MEMORANDUM

FILE NO.: CSP2013 0016

PROPOSAL: Widen and rehabilitate separated shared use path along Mendenhall Loop Road.

BACKLOOP SHARED USE PATH REHABILITATION PROJECT No. TEA-0966(27)~69917

STATE	YEAR
ALASKA	2013
SHEET NUMBER	TOTAL SHEETS
F9	38

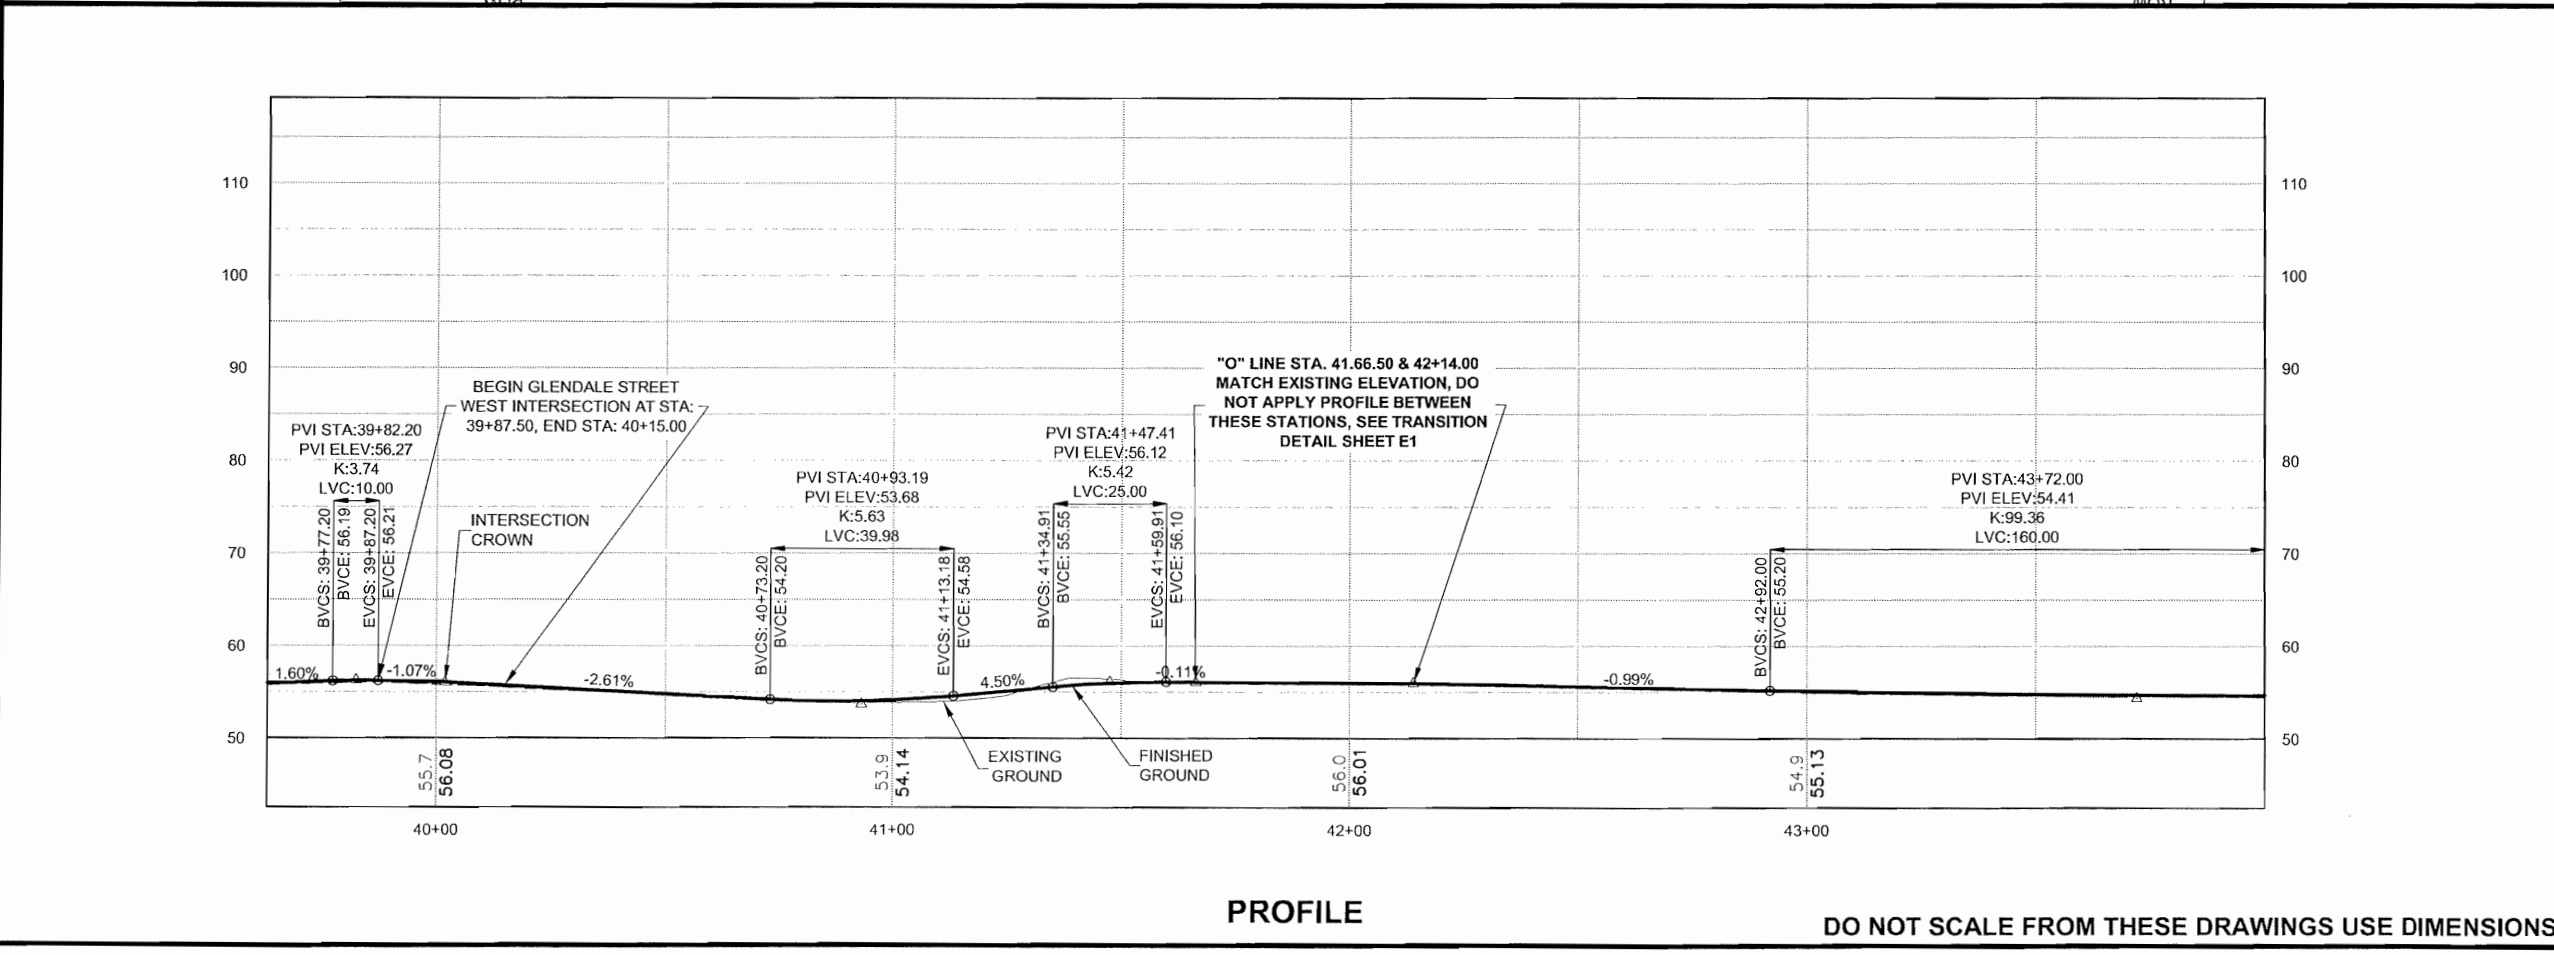
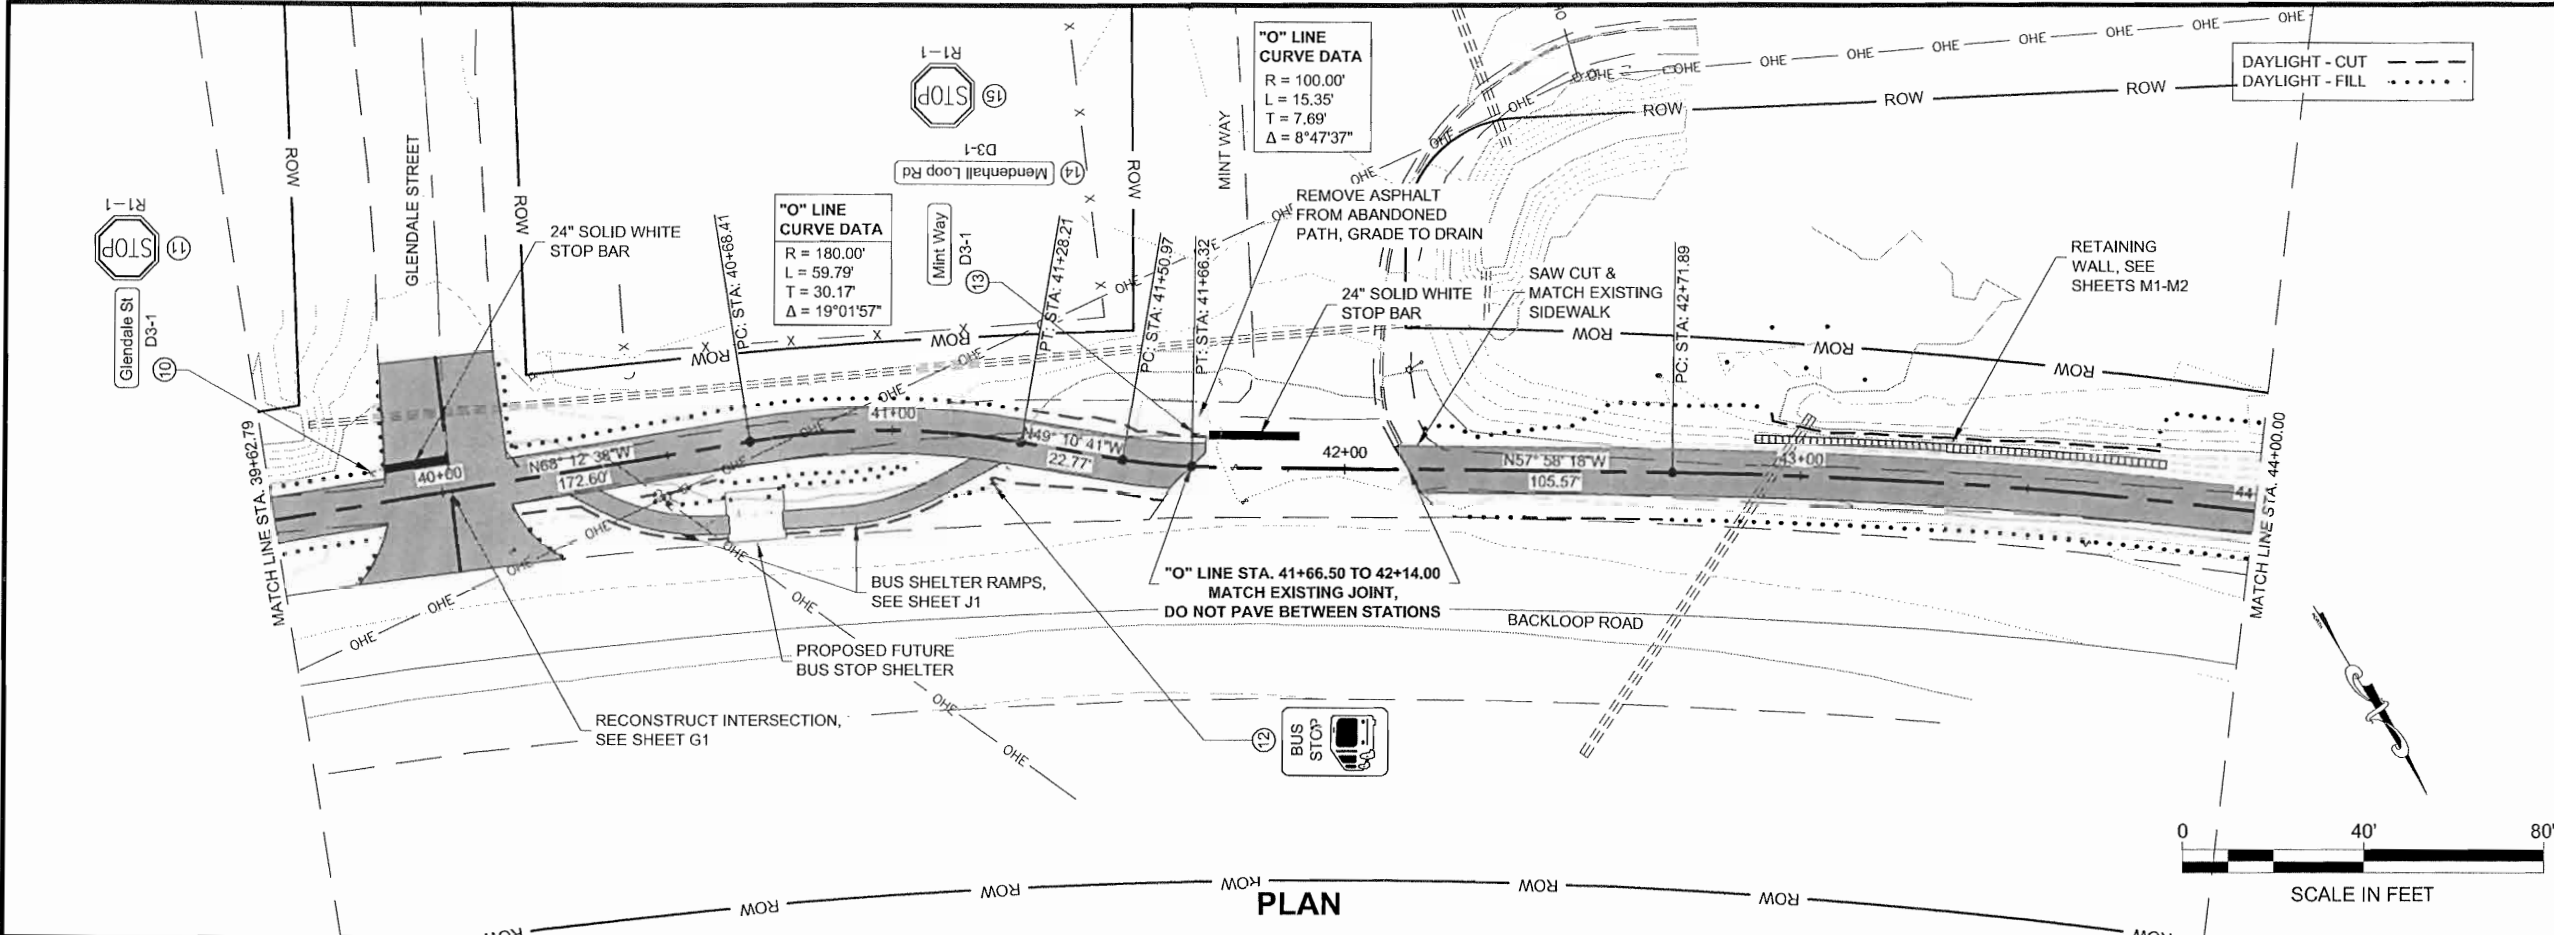
During environmental scoping for the project, CBJ staff identified a gap in the recreational trail system that could connect North Riverside Drive to the separated path that will be rehabilitated

in this project. CBJ agencies may work to close this gap by re-opening a historical trail that once connected North Riverside Drive to the Mendenhall Loop Road in the future. At CBJ request, DOT&PF incorporated a connection to this trail in the proposed project; this connection is shown on sheet F9 of the application.

BUS STOP RAMP PLAN & PROFILE

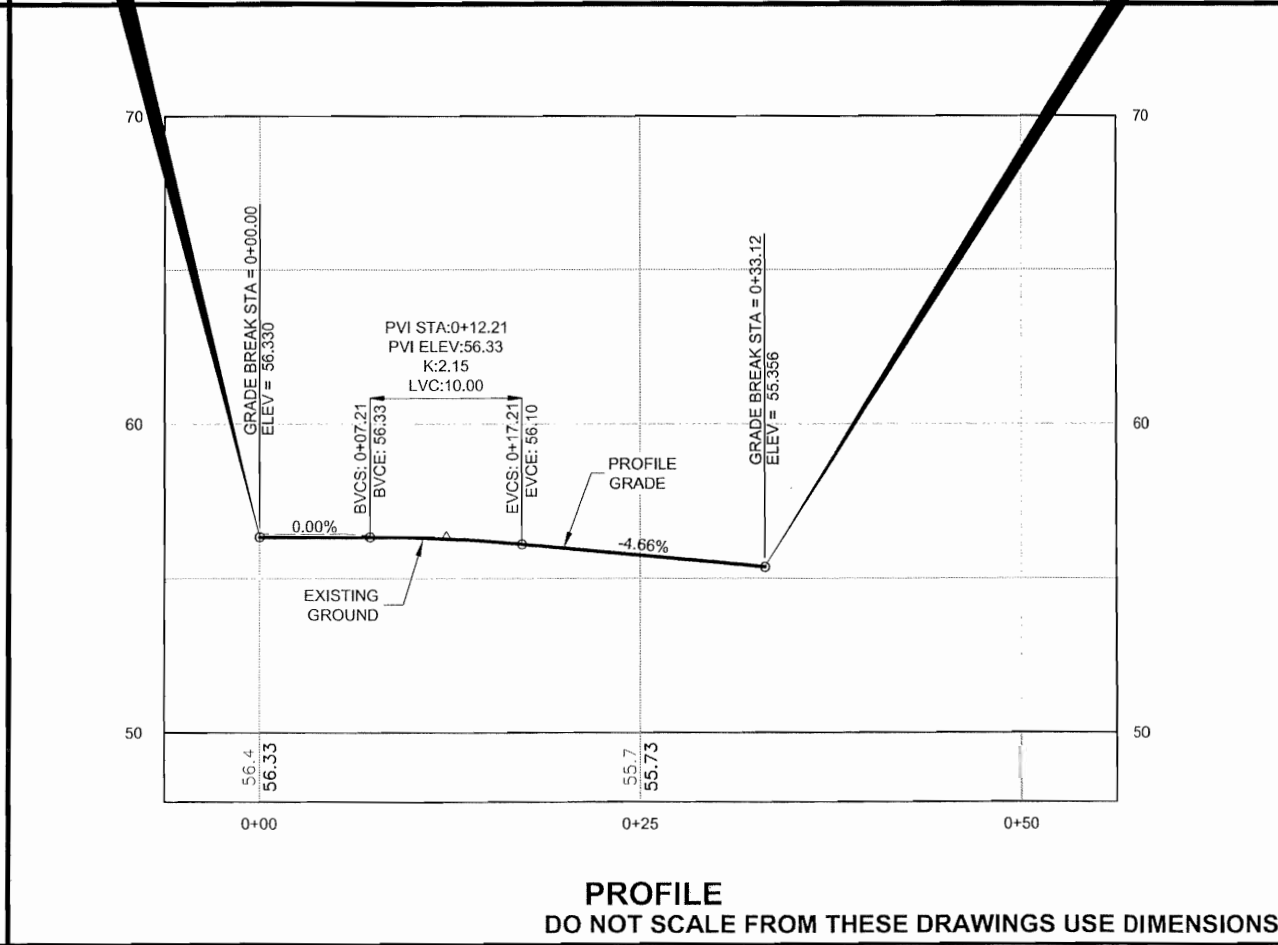
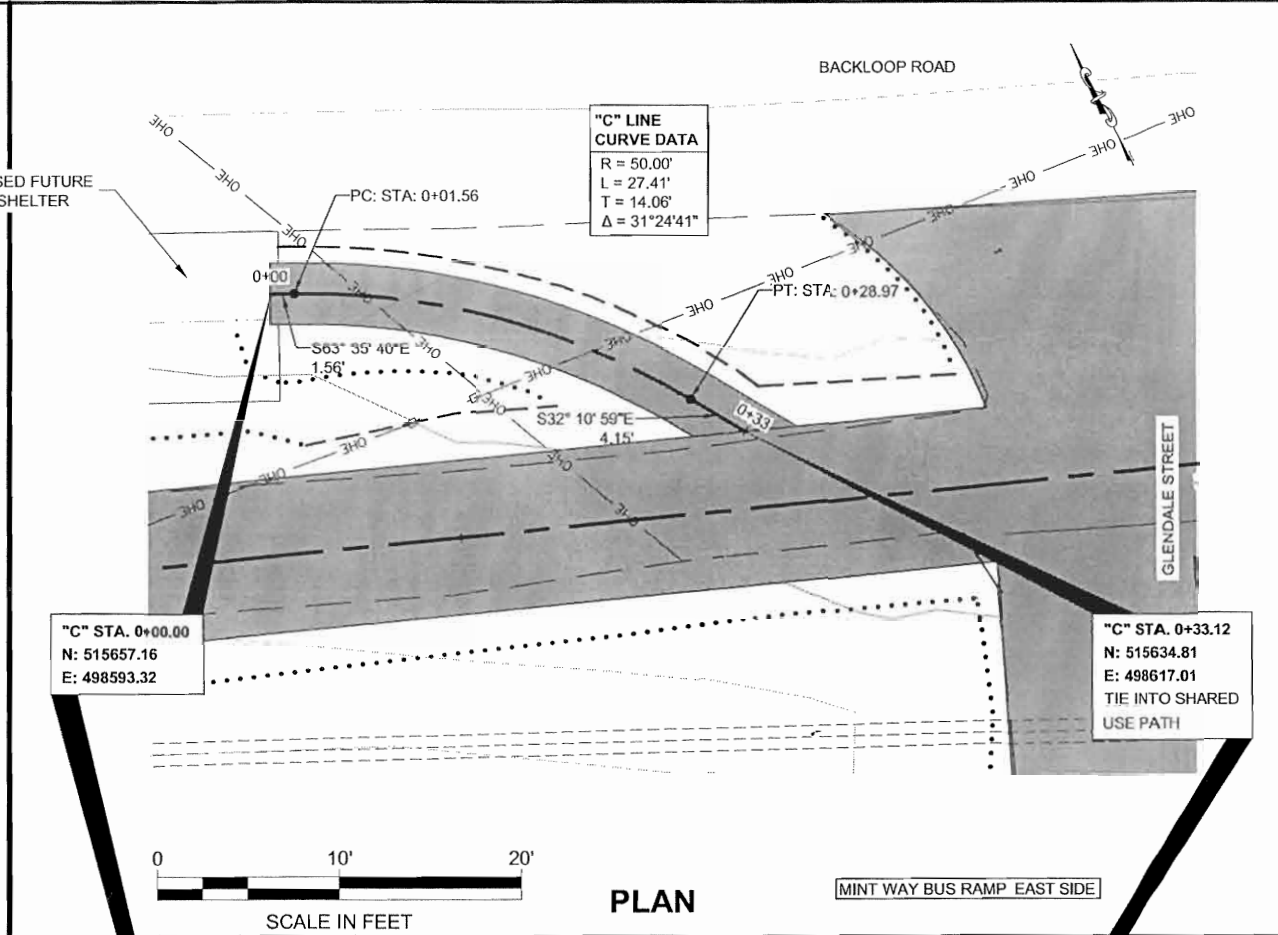
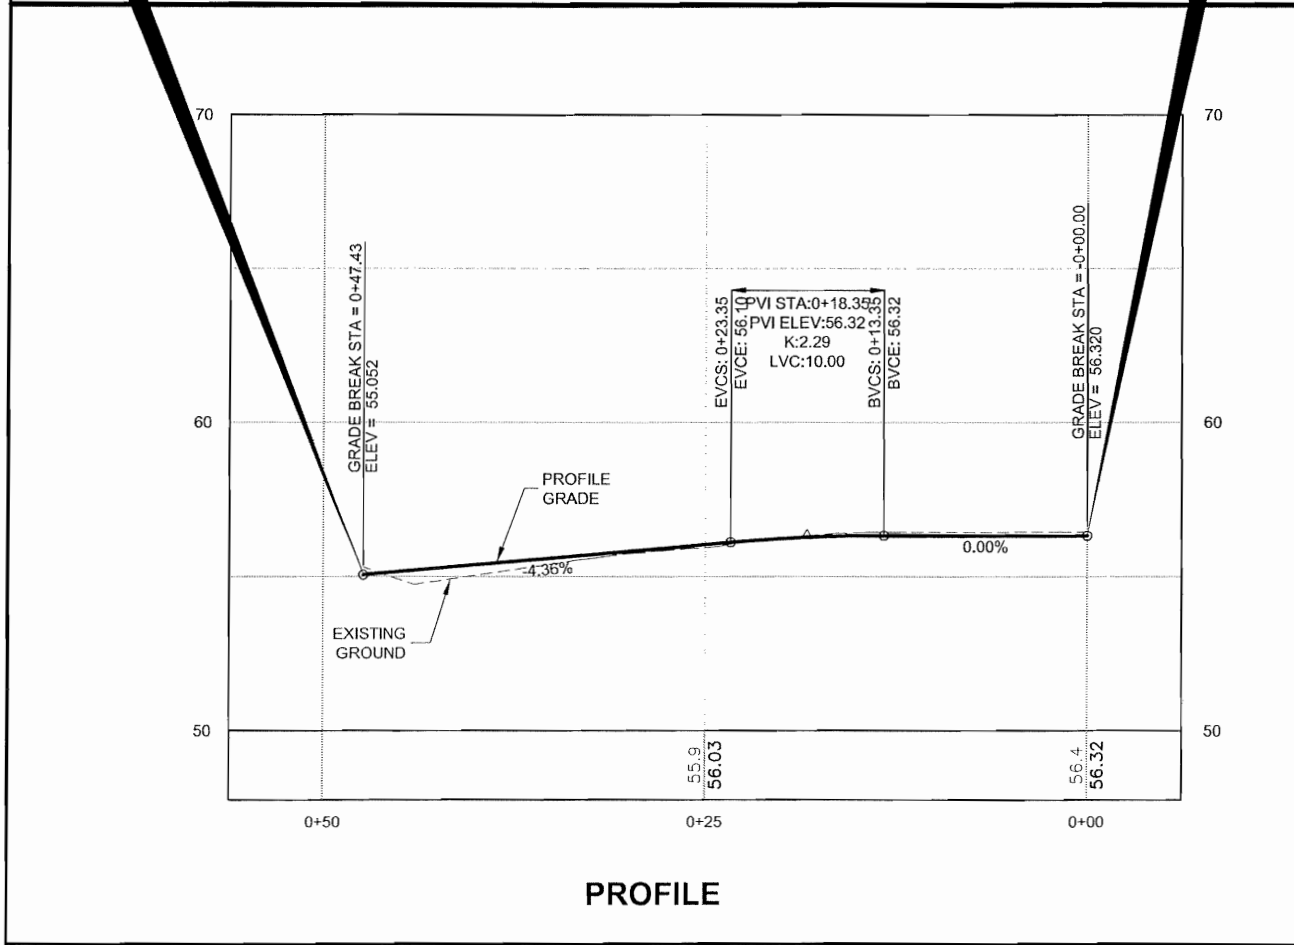
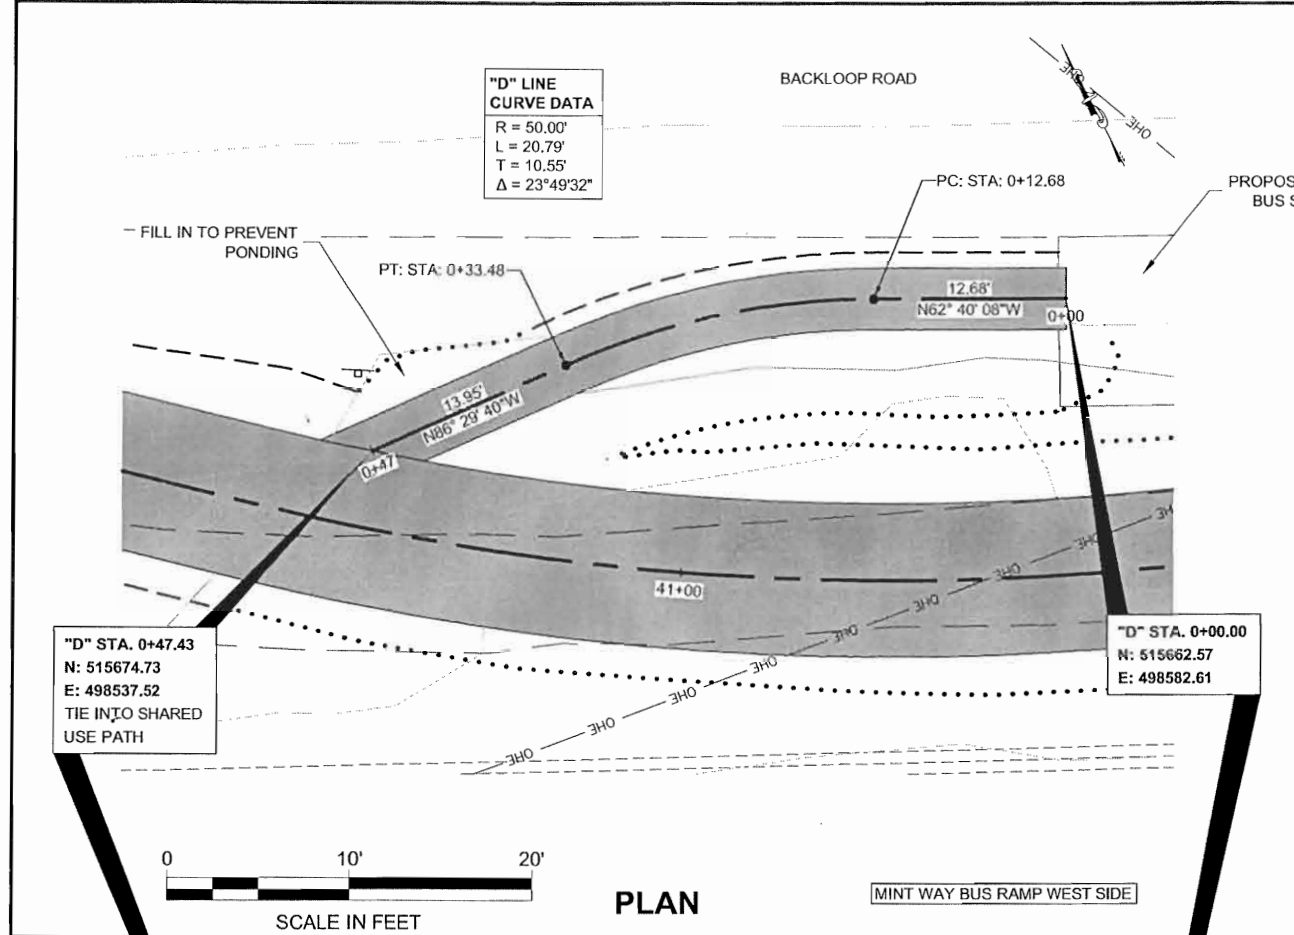
According to the July 18, 2013 letter from Jane Gendron (DOT&PF SE Region Environmental Manager)(Attachment B), the project was originally scoped as including a new Capital Transit bus stop and shelter “near Mint Way or Glendale Street”, “the following activities have since been added to the project scope:

- Construct an ADA accessible ramp to the bus shelter from the shared use path
- Omit the previously proposed new bus shelter and its concrete pad between Mint Way and Glendale Street; the structure is to be constructed by City and Borough

Given that DOT&PF has taken a very strict stance on where bus shelters may be installed by the City and Borough of Juneau, that the City and Borough of Juneau has not agreed to take on the responsibility of constructing the bus shelter or pad that is mentioned above, and that the CBJ has no funds allocated for the construction of this shelter or pad, both Capital Transit and Engineering Department staff oppose the project modification regarding the transit stop described above. Additionally, if DOT&PF constructs the ADA ramps as proposed, but does not construct the pad, the functionality of the ramps in providing ADA-compliant access to the bus stop will be negatively impacted. Riders will have to navigate from the paved ramps onto an unpaved waiting and loading area. Accordingly, staff recommends that a condition be placed on the finding of consistency with locally-adopted plans that would require DOT&PF to construct a pad at the bus stop location, connecting the ADA access ramps to the paved roadway and providing a complete ADA-compliant route between the bus and the separated path. Furthermore, staff recommends that due to historical problems with obtaining Right-of-Way permits from DOT&PF, a permit for the proposed bus shelter be issued by DOT&PF to the CBJ/Capital Transit prior to construction of the ADA ramps or bus shelter pad; this will ensure that the CBJ will be allowed to install a shelter in this location when funding for that shelter becomes available.

1. The applicant shall construct a pad for a future bus shelter where the proposed ADA accessible ramps access the road. A permit allowing the CBJ to construct a shelter over the pad at a future date, when funding allows, shall be issued prior to the commencement of construction on this project. If the bus stop must be relocated in order for this permit to be issued, the ADA accessible ramps and bus stop location shall be modified so that a permit for the shelter's placement in the vicinity of its current location can be issued; any relocation of the bus stop must be agreed to by Capital Transit.
